California High-Speed Rail Authority

RFP No.: HSR 13-57

**Request for Proposal for Design-Build
Services for Construction Package 2-3**

Book IV, Part G.1 – Design Variance Report

Appendix A – Record Set CB1824 through CB1830

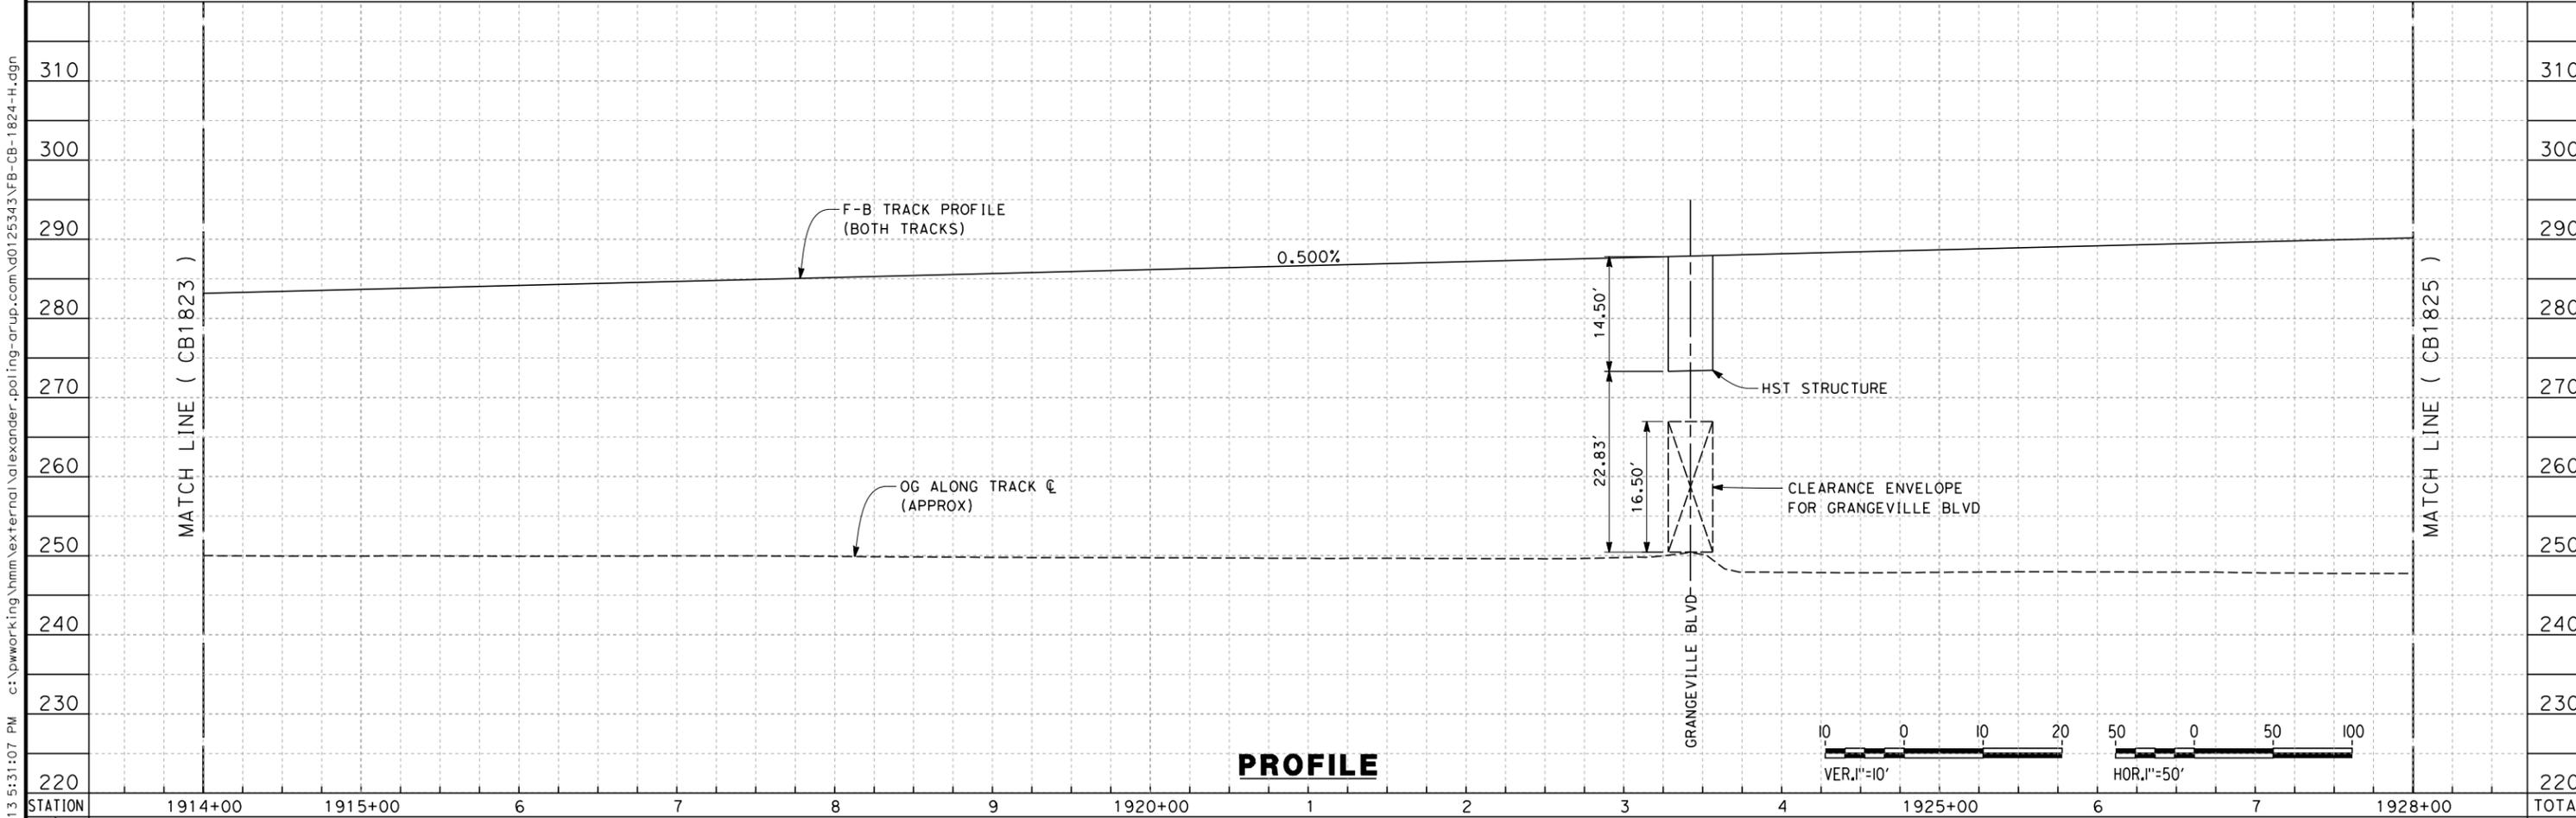
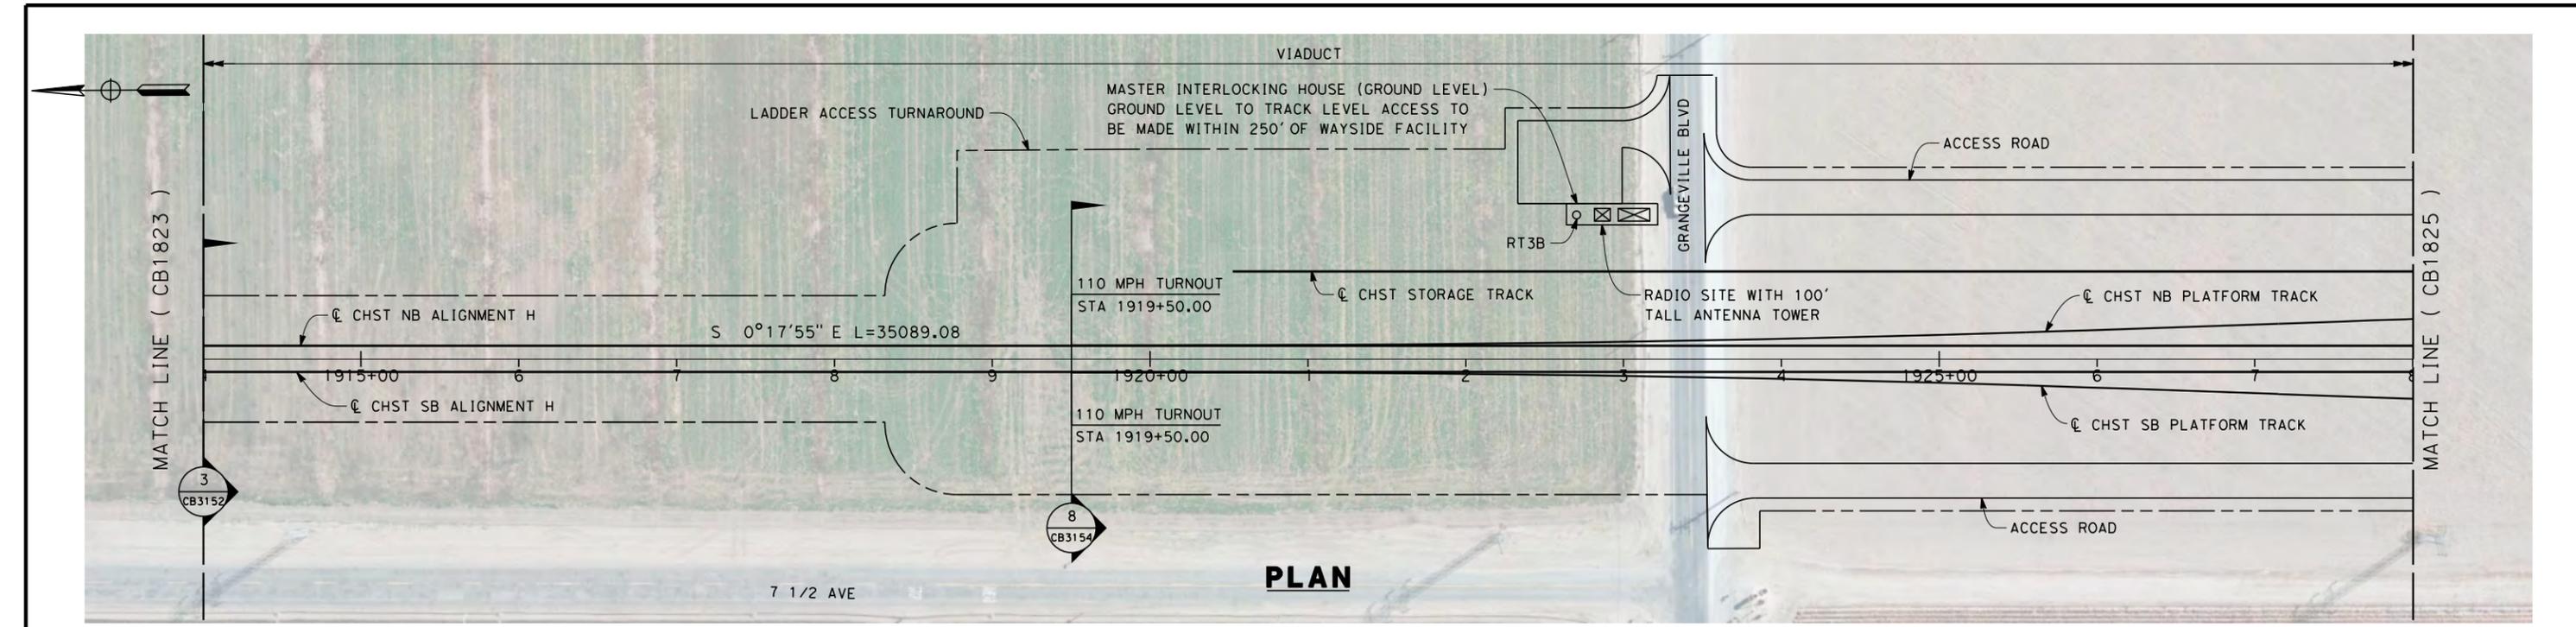
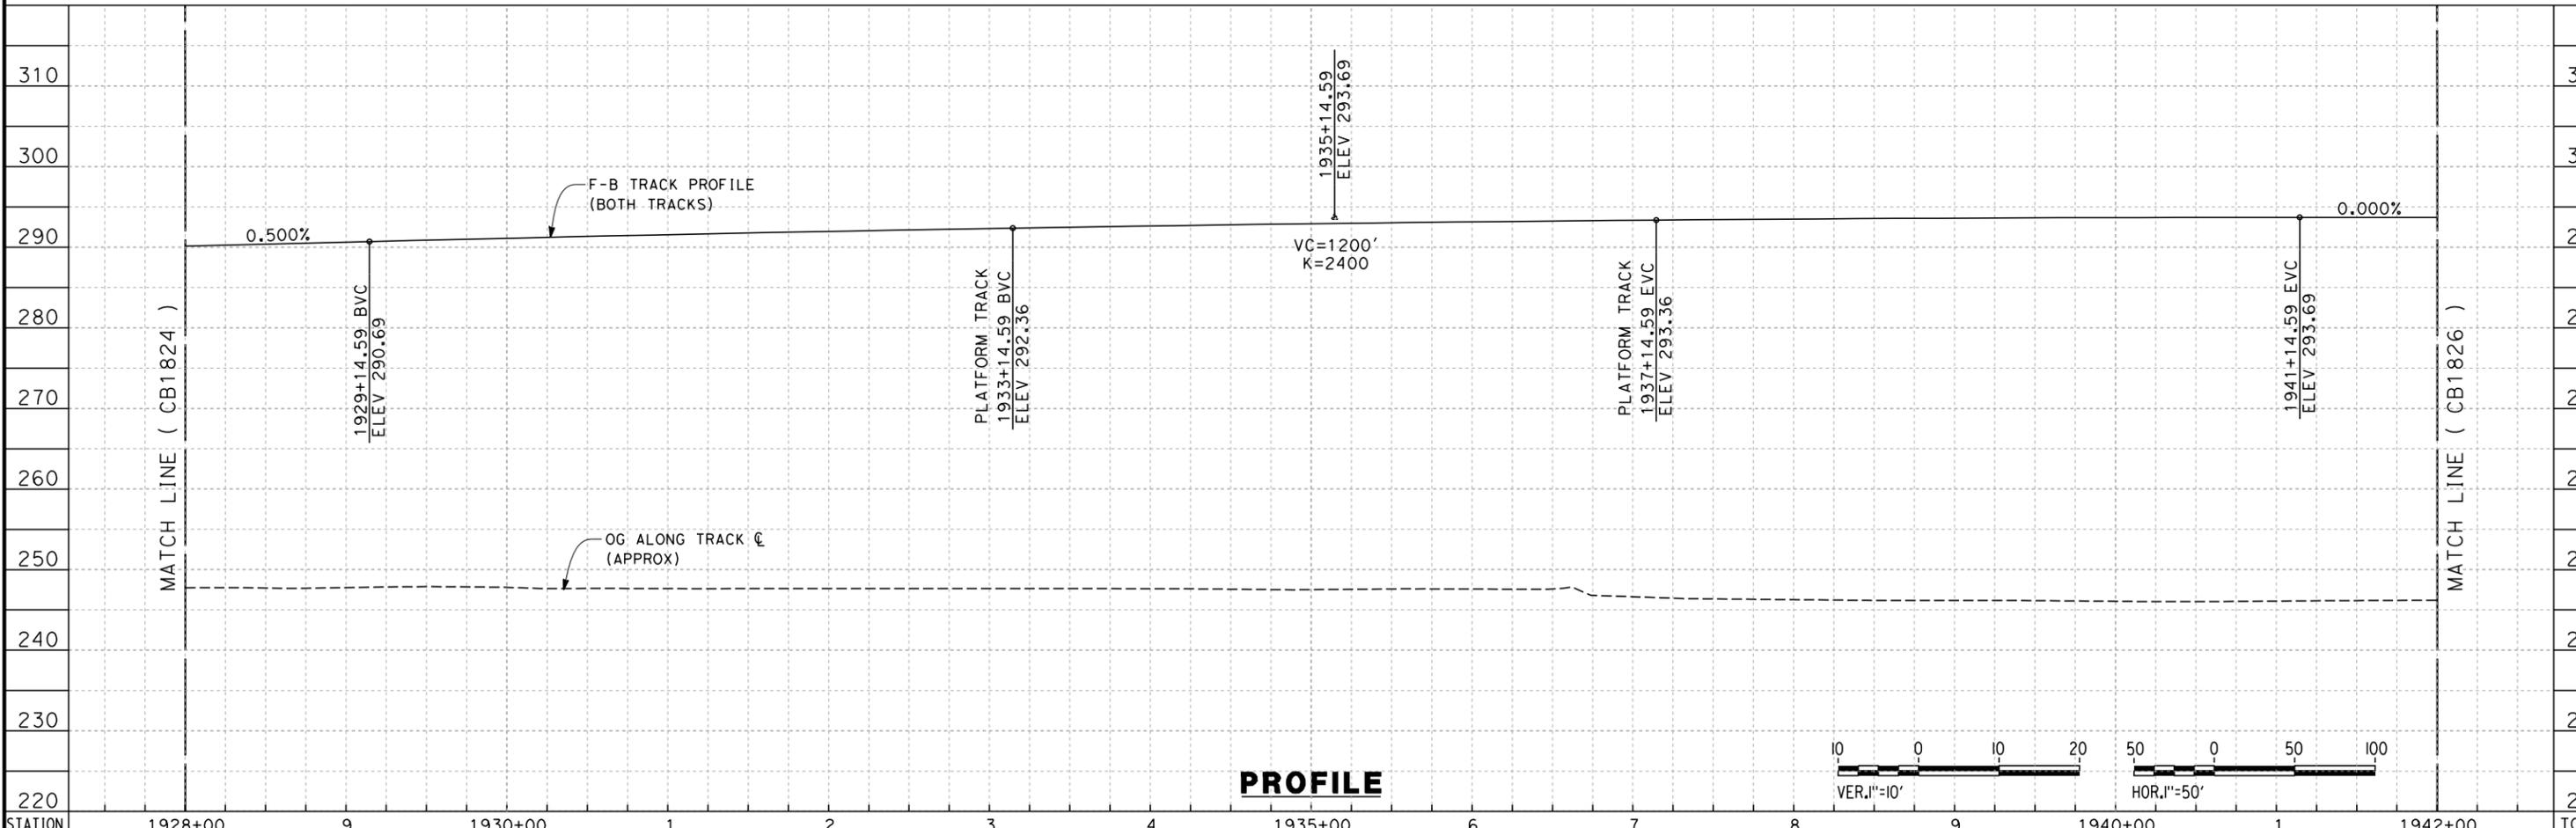
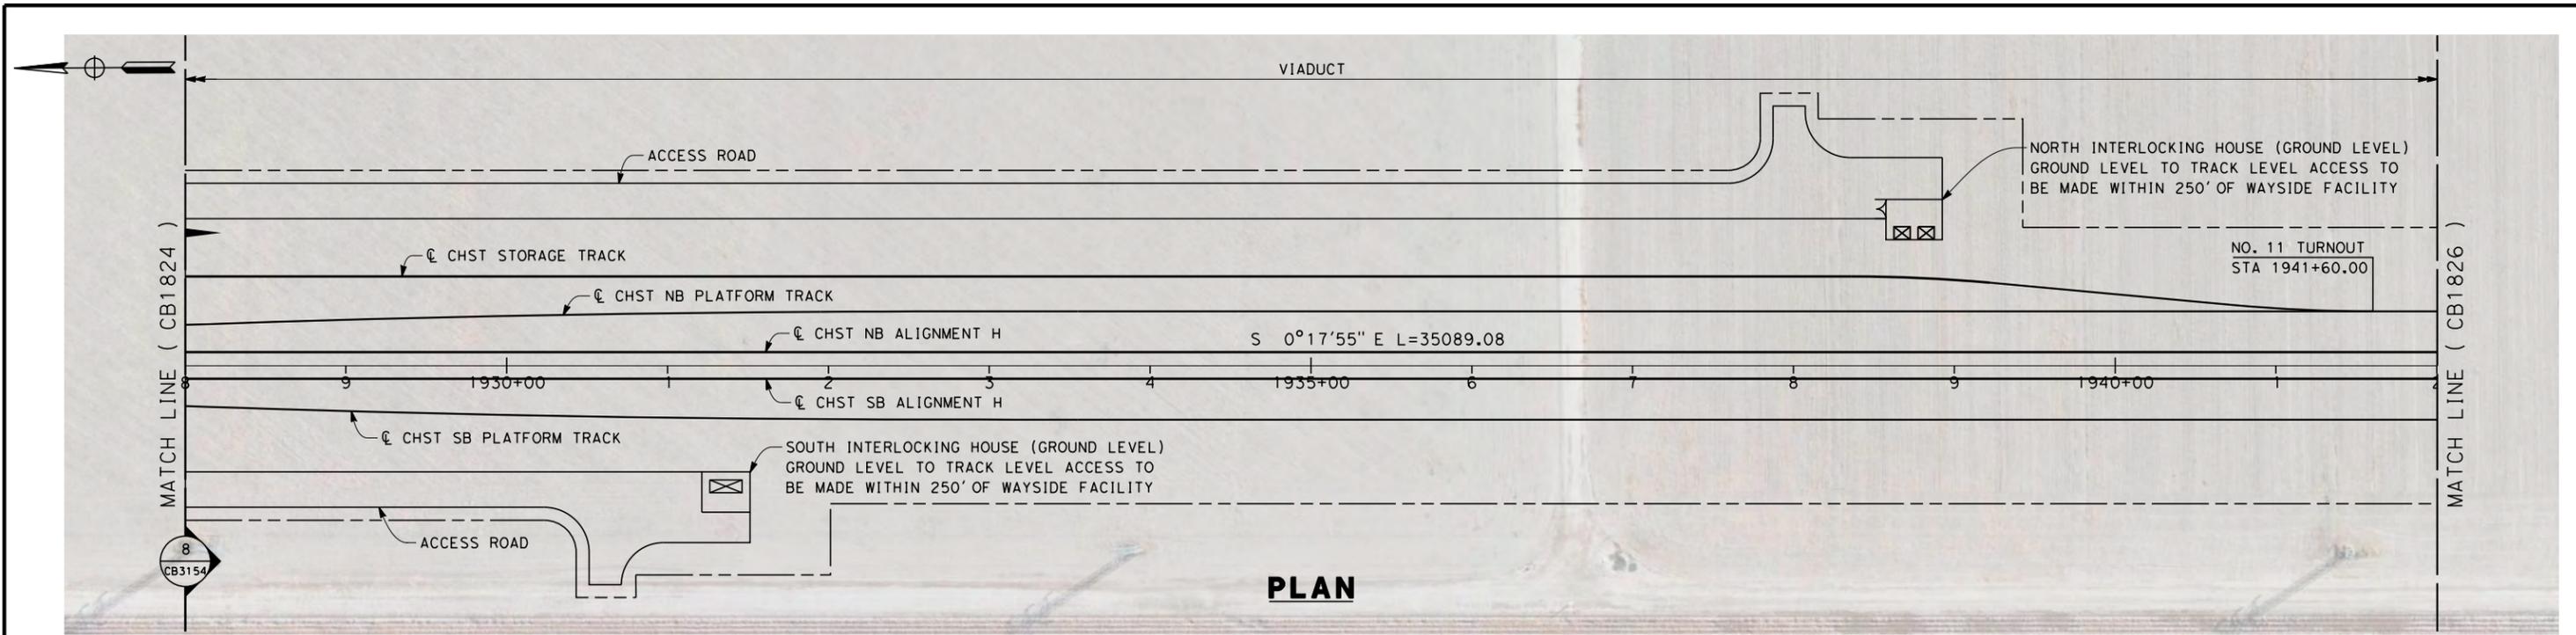
<p>REASON FOR REQUESTING A VARIANCE</p>	<p>The horizontal spiral in the return curve of the 110 mph turnout is coincident with the beginning of the vertical curve of the station tracks at all four quadrants. This does not provide the exceptional 1.5 seconds of attenuation time (242 feet) indicated in TM 2.1.2 Section 6.1.1 or the minimum 100 feet called for in TM 2.1.2 Section 6.1.7.</p>
<p>JUSTIFICATION FOR VARIANCE</p>	<p>Kings/Tulare Regional Station is raised on a viaduct and requires vertical curves north and south of the station to lower the tracks back to grade. The vertical curves are on the mainline between the turnout for station tracks and the platforms. This allows for appropriate attenuation length on the mainline and a 0% grade throughout the station.</p> <p>The 15% Record Set design provides the standard 6,000-foot station tracks at 110 mph (from point of switch to point of switch). For this length the</p>

<p>approaching the station would need to reduce speed earlier due to the turnout's location farther from the station. A design variance to Directive Drawing 2.1.3 – Interlock A would be required for the nonstandard position of the station turnouts.</p> <p><u>South of the Station</u> Desirable attenuation can be provided between the return curve spiral and the vertical curve of the station tracks south of the station by sliding the station track turnouts 610 feet south. The mainline vertical curve south of the turnouts would achieve the minimum length (1,200 feet), and the four-track viaduct would require lengthening by 610 feet. The shift south would also require relocating one system site and lengthening the access road. The distance between the station turnouts and station crossovers would decrease by 610 feet.</p> <p><u>North of the Station</u> Desirable attenuation can be provided between the return curve spiral and the vertical curve of the station tracks north of the station by sliding the station track turnouts 388 feet north. This would require lengthening the four-track viaduct by 388 feet. The shift north also requires relocation of a systems site and lengthening of the access road.</p>

OPERATIONS	None identified
MAINTENANCE	Slab track could be used to mitigate maintenance concerns of providing the station track spiral coincident with the beginning of the vertical curve.
INFRASTRUCTURE	None identified
RAILROAD SYSTEMS	None identified
OTHER	The vertical curve was located coincident with the station track spiral to avoid introducing a segment shorter than the length required to provide minimum attenuation. Ride quality may also be reduced; however, designing the two elements coincident allows the horizontal and vertical moves to occur simultaneously.
